Water Leakage into VDC-455, VDM-455,  
VDC-485, and VDN-495

July 27, 2007

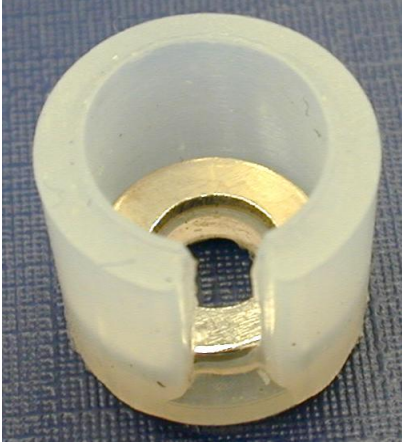
Tolerances on the cap of the VDA-445WMT Wall Mount and the VDA-455PMT Pipe Mount may cause water to leak into the VDC-455, VDM-455, VDC-485, and the VDN-495.

There is a tolerance risk on two dimensions in the Wall Mount cap:

- The diameter of the cap is close to its maximum.
- The length of the pillars, on which the camera is mounted, is close to the minimum end of the permitted tolerances.

The combination of the two tolerances causes the metal ring around the dome bubble to get blocked on the cap before it seals the bubble onto the camera base.

- The thickness of the paint layer added to the machined diameter causes the total diameter of the cap to be close to the maximum.
- The length of the pillars is close to the minimum due to the de-burring process.

Products with the potential problem have no special markings nor have clips on the three pillars onto which the FlexiDome cameras are mounted.

It is recommended to add clips on the pillars inside the cap to reduce the risk of water ingress when used in applications exposed to rain or water sprays. Clips and washers for this modification are available through Bosch Security Systems Technical Support.

1. Put a washer inside the clip (see photo) and slide the clip with washer onto the pillar.

2. Make the connections and mount the FlexiDome onto the cap.
3. To check that the dome bubble makes a watertight seal, firmly push down on the metal dome ring with the bubble before tightening the three security screws. The seal is correct when the dome ring can be pushed down somewhat (compressing the rubber sealing ring) and springs back when released.
4. Tighten the security screws.
